June 29, 2001

JB 18457-I

Addendum Geologic and Soils Engineering Exploration Report #2
Proposed Landslide Repair and Multi-Unit Condominium and Town Home Buildings
Tentative Tract 52928
17331-17333 Tramonto Drive
Pacific Palisades, California

Grading Section Log # 31587-01

SECTIONS D, E, F & G
 G.H. PALMER
 LANDMARK ILLC.
 CONSULTANT: JAI SCALE: 1" = 40'

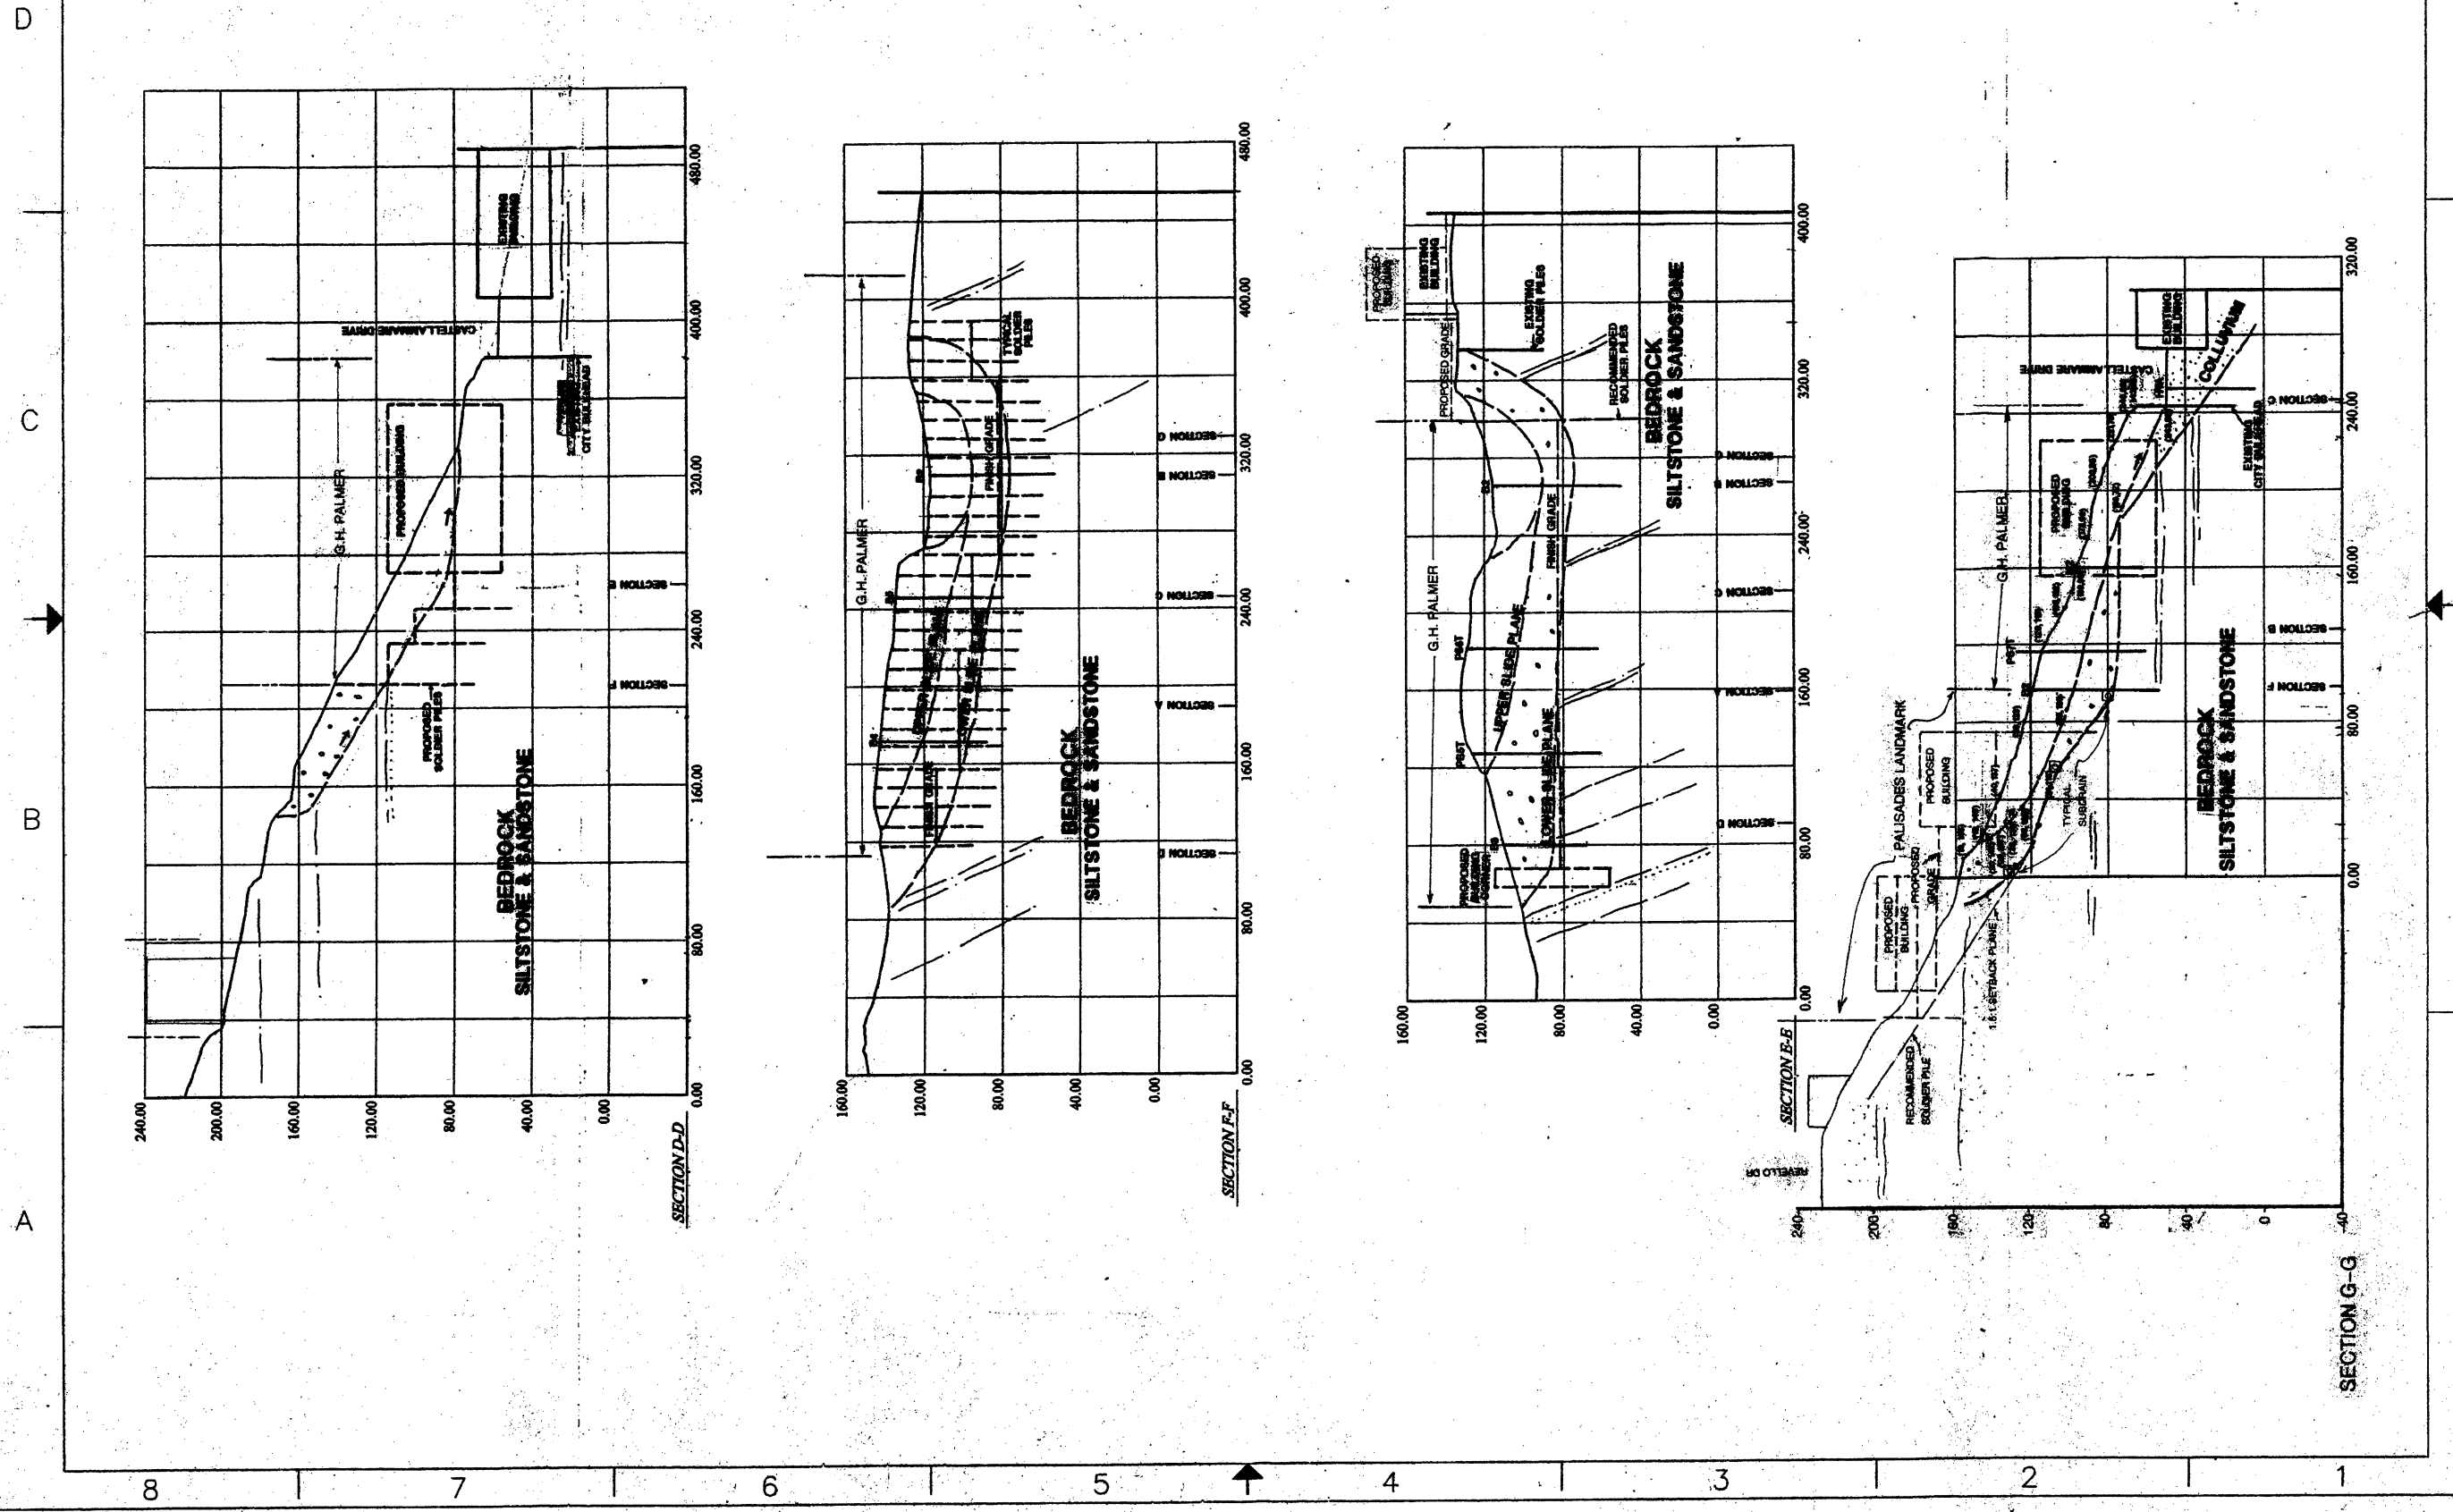
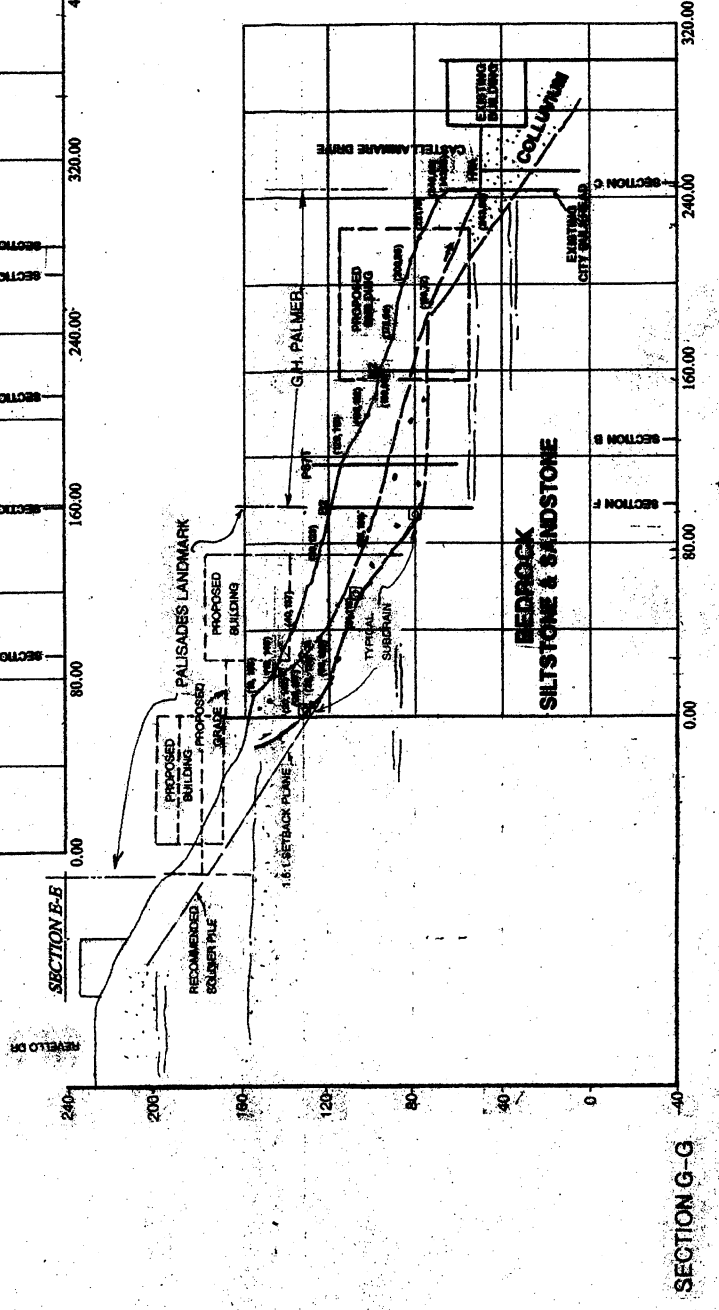
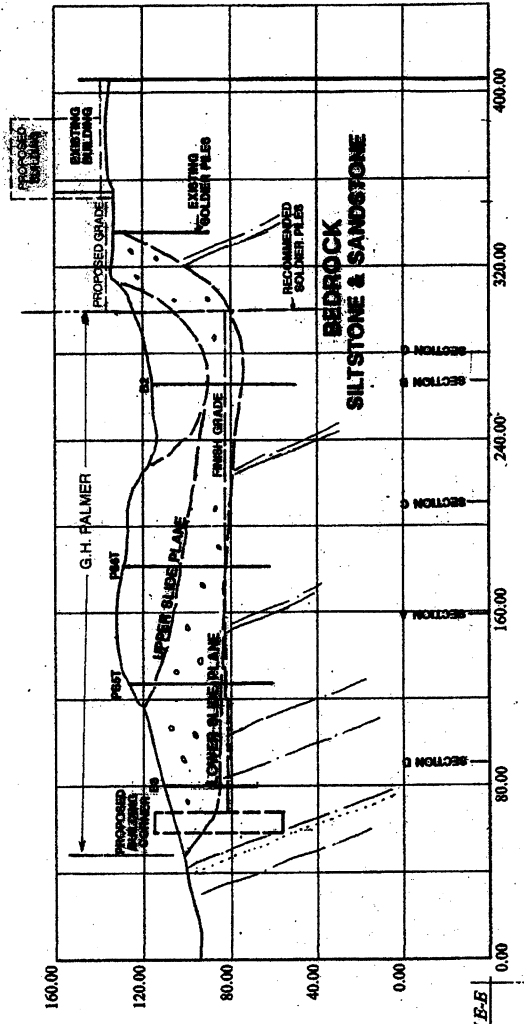
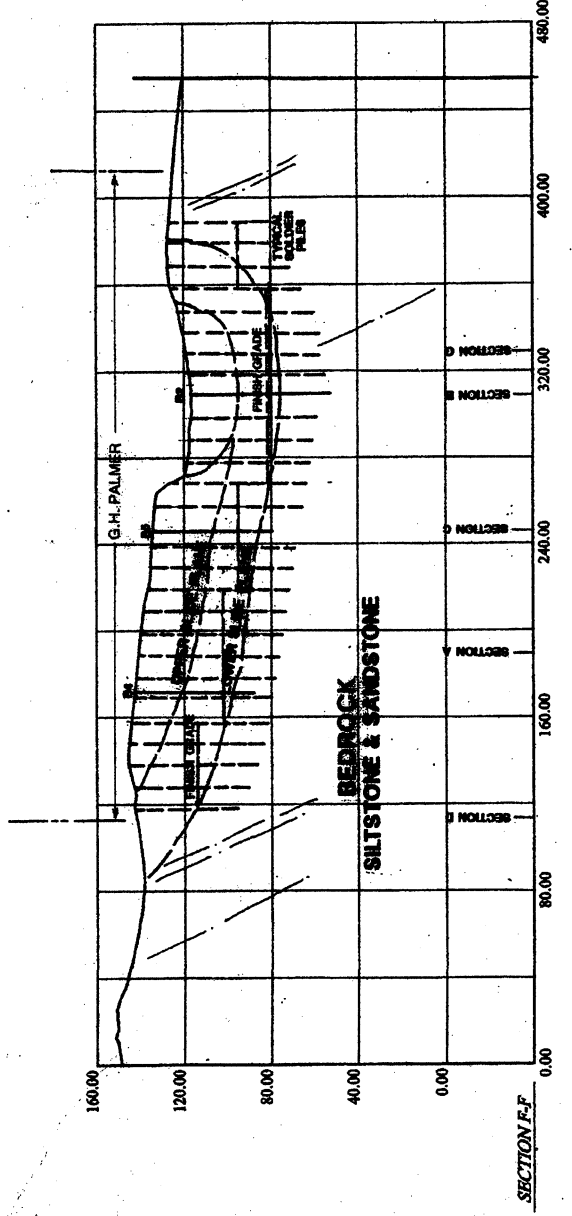
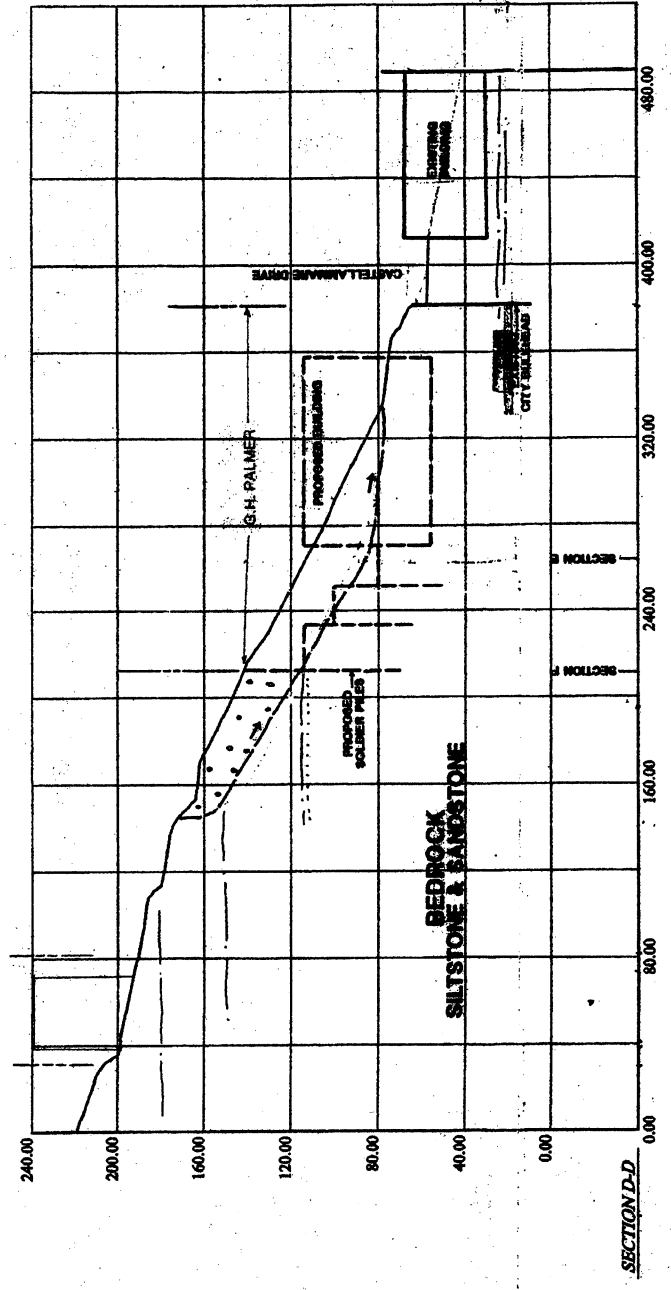
Item 8 - *Extend easterly cross-section E-E to show toe the off-site slope.*

Item 9 - *Revise cross-sections E-E and G-G to show subject development. The structures described as proposed structures are actually proposed structures for G.H. Palmer & Associates site, and not for the subject site. Cross-section G-G shall be extended to show Revello Drive.*

The easterly extension of Section E, which shows the offsite slope, roughly coincides with Section O. Section O is believed to be the most critical section with respect to stability.

Sections E and G have been revised to show the proposed development. Also, Section G has been extended to Revello Drive.
